Bulletin No.:	HL19103140
Release Date:	12/3/2019
Effective Date:	IMMEDIATE
Supersedes:	HL19021240
Completion Date:	Opening 2021 (will vary)

SERVICE BULLETIN

Abstract of Issue:

Figure 1: Render of new Lift Chain Retainer design

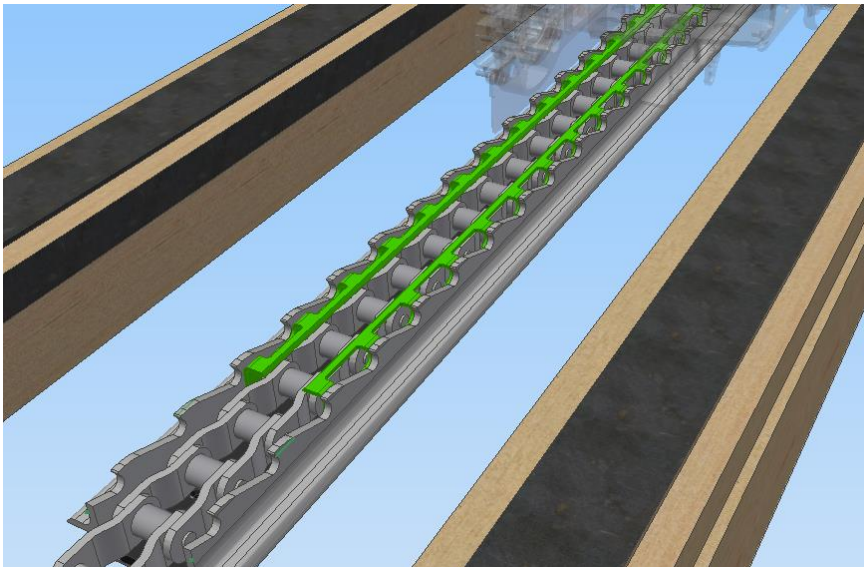
Like the current retainer angles, the new chain retainer is installed via welds to the ARB angle. However, the major difference is that the new design provides continuous coverage along the entire length of the chain trough. Refer to Figures 1 and 2. This reduces the risk of the chain leaving the trough, and directs the broken chain down the trough to gather near the motor base or the lower idler.

The newly-designed Lift Chain Retainer (1161-2201) must replace the existing chain retainer angles (SP07060442) along the flat portion of the entire lift hill. This requires that the current chain retainer angles be removed before the installation of the new retainer. Please refer to Note 1 on the included installation drawing for more details.

- A revised Lift Chain Retainer (1161-2201) must be installed in accordance with the included drawing (1161-2200).
- Modified Chain Dog Mount Weldments (98083005L) must be installed on all Millennium Flyer trains.
- Inspection of the chain **must be added to your end-of-season checklist** and performed according to the updated chain wear section of this bulletin.

Figure 2: Cross-sectional view of new Lift Chain Retainer design

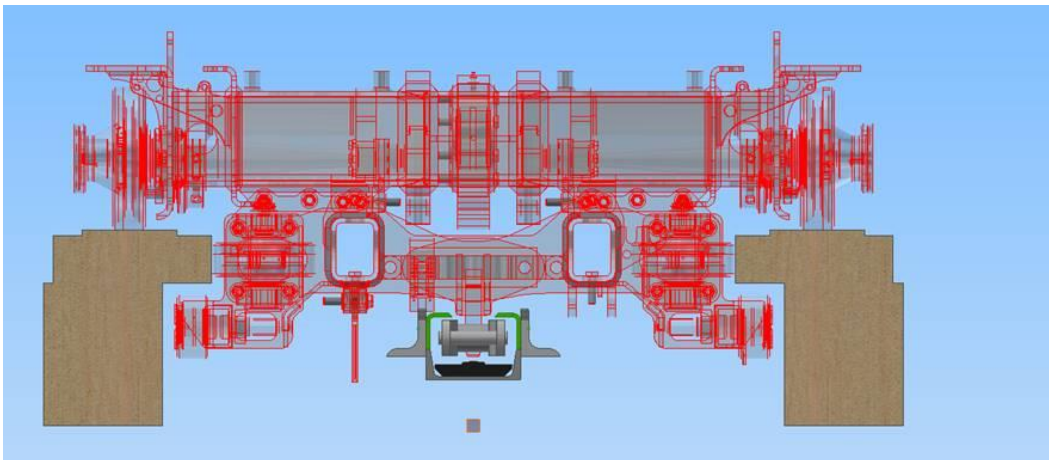
Another critical note regarding this modification is that all Millennium Flyer trains must be outfitted with the latest revision of the Chain Dog Mount Weldment (98083005L). ***Old-style chain dog mount weldments cannot be run with the new Lift Chain Retainer in place, as they do not meet the updated clearance requirements.***

For complete specifications and installation measurements, please refer to the included installation drawing. (1161-2200).
